# environmental statement

related to operation of  
**oconee nuclear station units  
1, 2 and 3**

**DUKE POWER COMPANY**

DOCKET Nos. 50 - 269, 50 - 270, 50 - 287

Fig. III-10. Expected normal areas of dissolved oxygen of less than 5 mg/l in Lake Keowee -- extreme conditions.

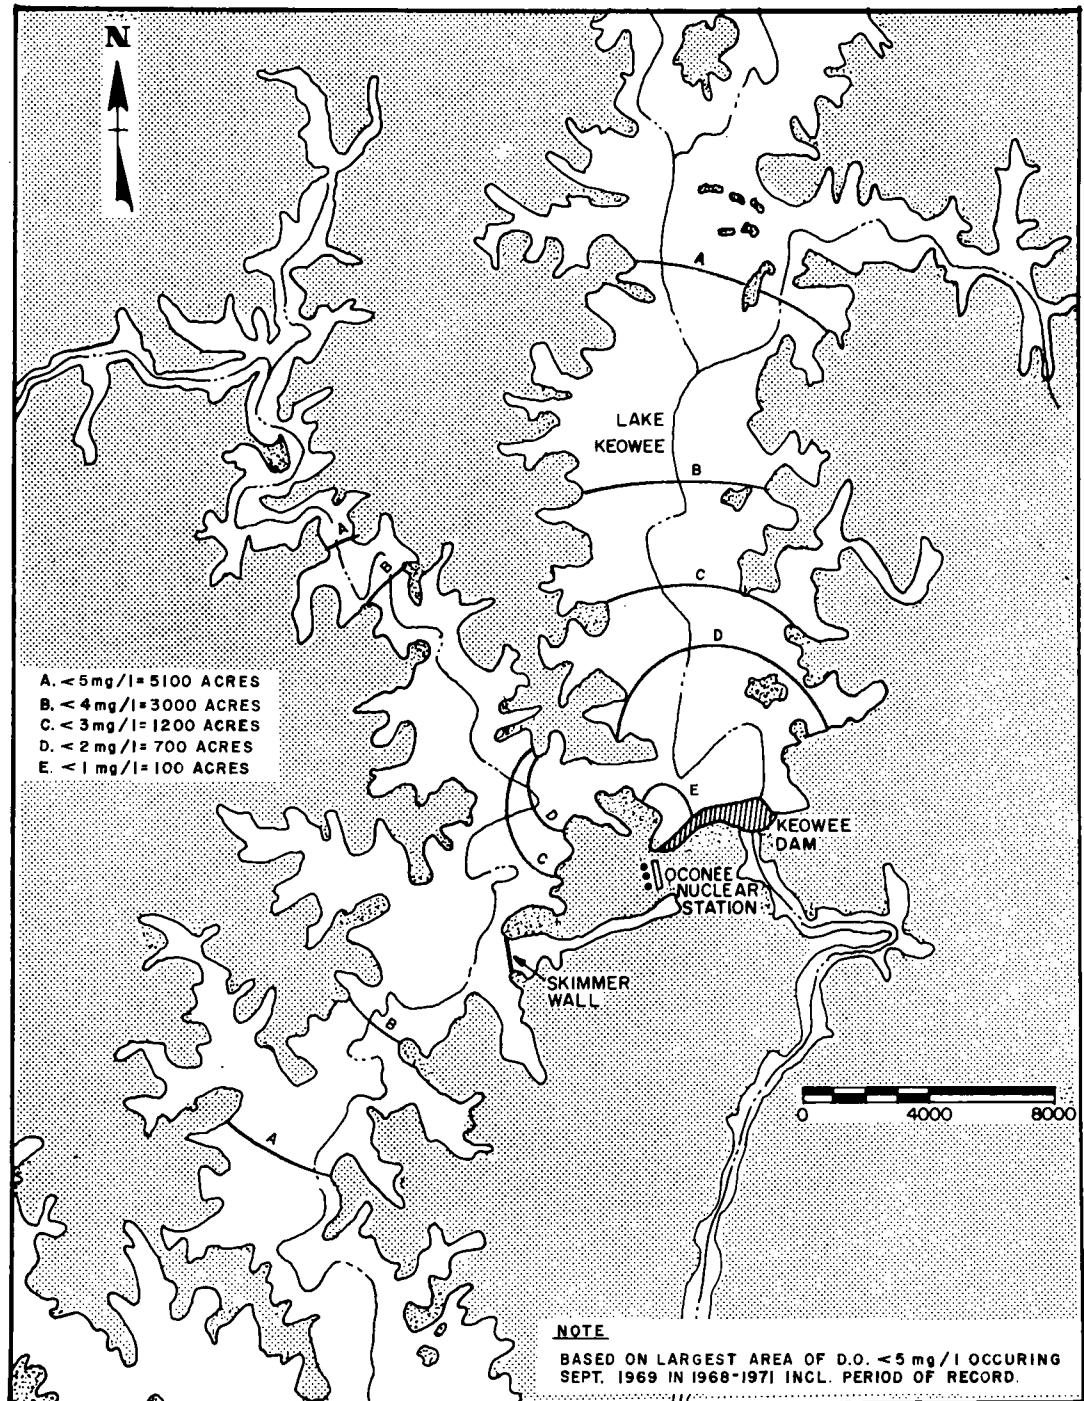
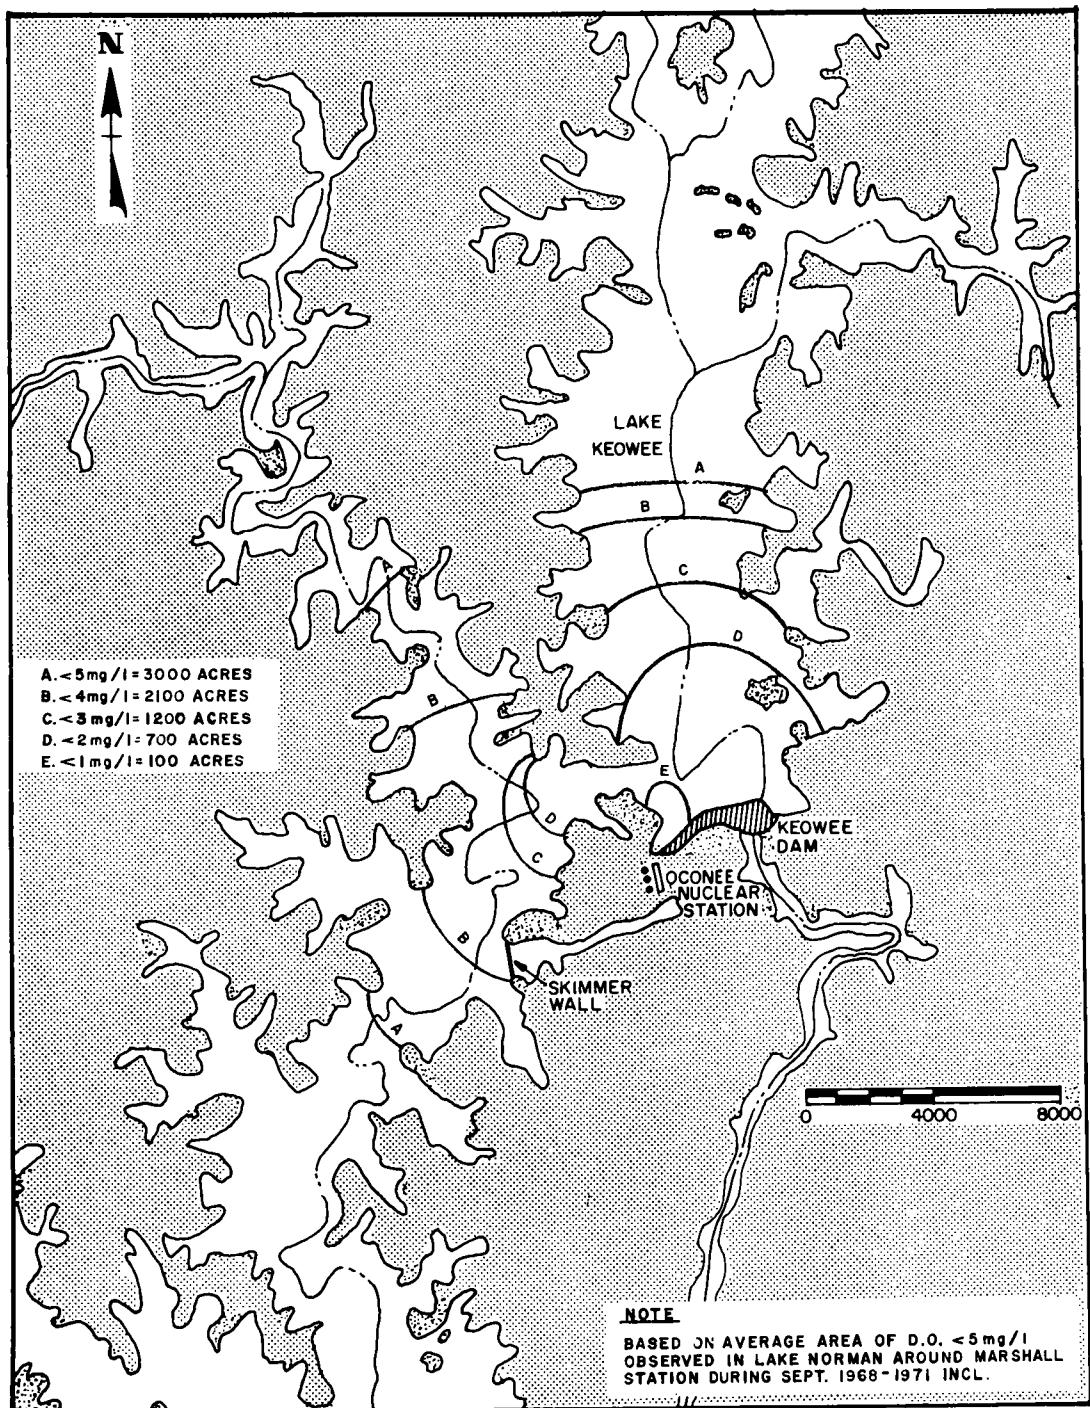
EPA-23	Changes related to thermal discharges; dissolved oxygen (D.O.) is potential critical problem during summer and fall. [Draft p.48, 77-78]	Sections III.D.1d under oxygen effect and in Figure III-10 and III-11. Biological Effects Section V.C.1.b.
EPA-24	A brief discussion of leakage or spillage of oil or other hazardous materials and prevention of their reaching water courses should be presented. [Draft p.79]	See Section III.D.3a thru d.
